SAFETY EVALUATION BY THE OFFICE OF NUCLEAR REACTOR REGULATION

RELATED TO AMENDMENT NO. 14 TO

RENEWED FACILITY OPERATING LICENSE NO. R-87

PURDUE UNIVERSITY

Figure 1 - Simplified RCS Block Diagram

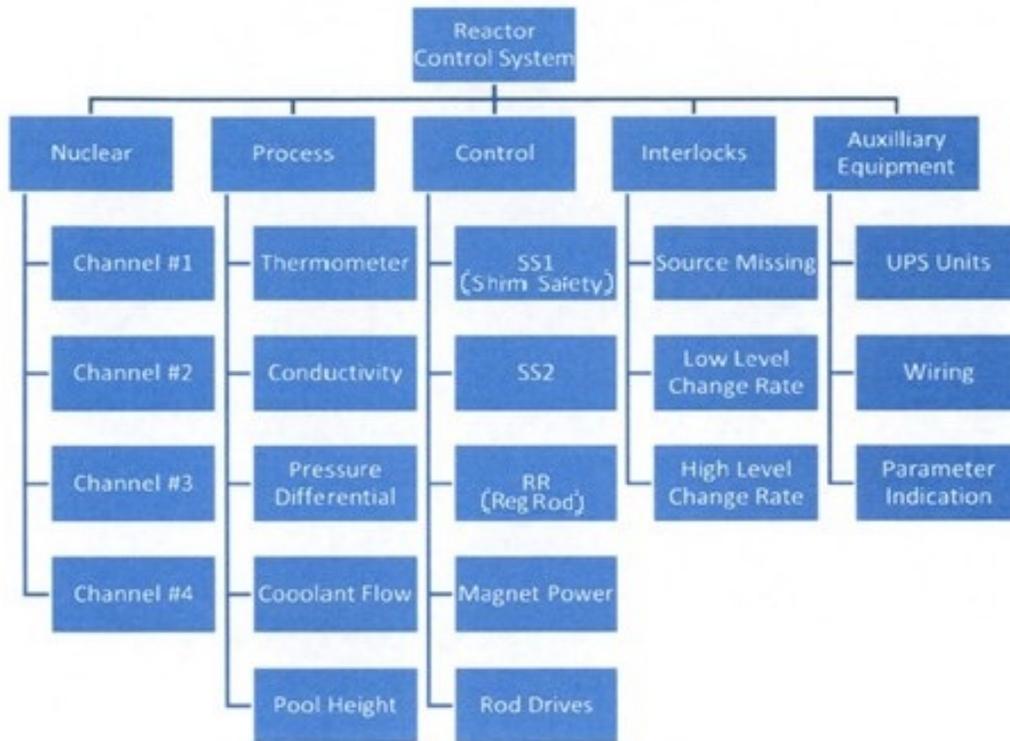
Figure 1, which is based on Figure 7-2 from the LAR, is a simplified block diagram of the RPCS. A system description of the RCS (Section 3.2.1) and its subsystems (Sections 3.2.1.1 – 3.2.1.7), based on these references, follows Figure 1.

Figure 2 – Simplified Block Diagram of RPS Magnet Circuit Interrupts

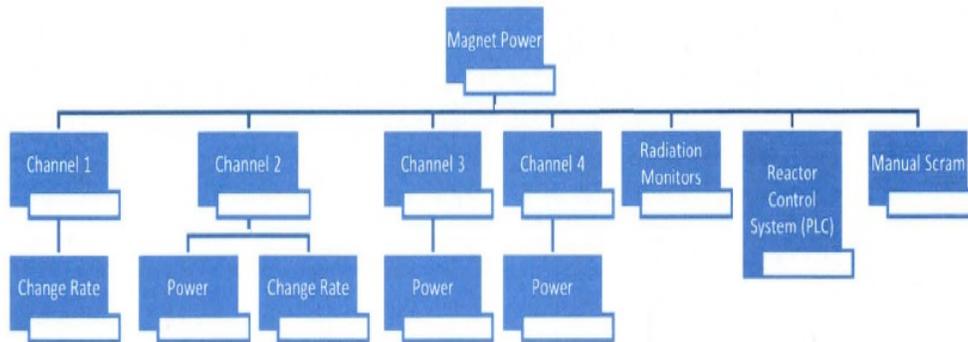
The RPS consists of a constant current power source that is wired through several relays connected in series to the shim-safety rod magnets. These relays receive scram signals from the RMS, the NFMS, the RCS and manual scram inputs. If any scram signal is received, the associated relay contacts open, removing power to the shim-safety rods' magnets, and cause the shim-safety rods to drop into the core, shutting down the reactor. The scram signals connected to the relays in the magnet power circuitry are:

Figure 4 - PUR-1 Main Operator screen

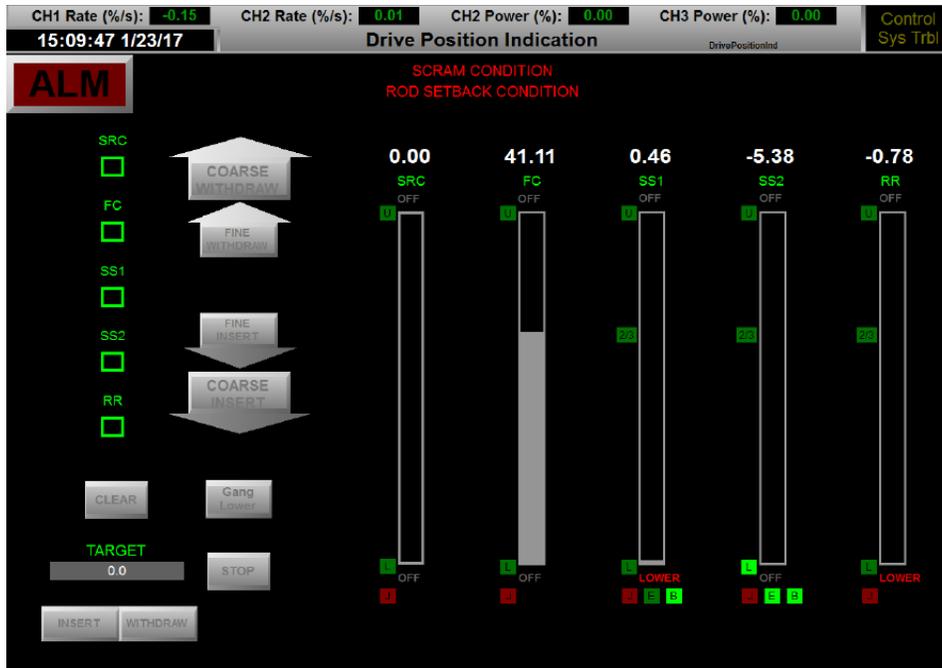
The main screen of the primary operator workstation, as shown in Figure 4, indicates reactor power and change rate. It also allows for rod position control, as discussed previously in Section 3.2.1.2 of this SE. As described in Section 7.6.b of the LAR (Ref. 1), the operator may move the rods manually, using fine or coarse withdraw, or by inputting a desired height. Through manual control, the operator may select the drive, which is desired to be moved. A joystick can then be lifted or depressed indicating upward or downward motion of the rod, respectively. When the joystick is lifted or depressed and a rod withdrawal inhibit is not active, the rod will continue to drive in the direction the operator positioned the joystick. The operator may stop rod motion at any time through toggling the joystick or selecting stop on the operator screen. Clicking on the Selected Drive Coarse/Fine Withdraw button requests the control algorithm withdraw the selected drives one "course"/"fine" step. The position change for one "fine step" is unique to each drive and a programmed setting parameter in the control algorithm. Each press of the selected drive coarse/fine withdraw button withdraws the drives only one-step, the button must be pressed for each step of withdrawal.

Figure 6 - Digital Annunciator screen showing a Makeup Water RAM Scram

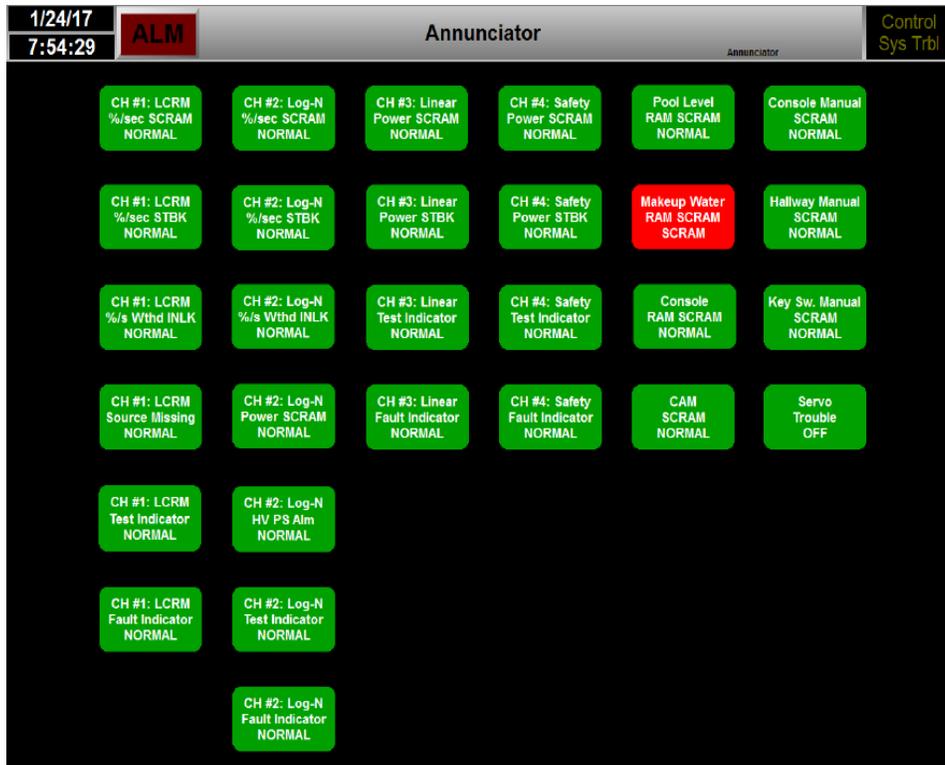
Figure 6 provides an example of the color and wording change for a scram. The figure provides the example, "Makeup Water RAM SCRAM," which shows the indicator has changed from "green" to "red" and the wording changed from "NORMAL" to "SCRAM". The operator can select each annunciator alarm by "left-clicking" the indicator to display trends and graphs. The trends and graphs allow the operator to display any parameter value. The graphs are auto-scaling (which the operator can control) and bad signal quality is indicated with a magenta colored plot line.
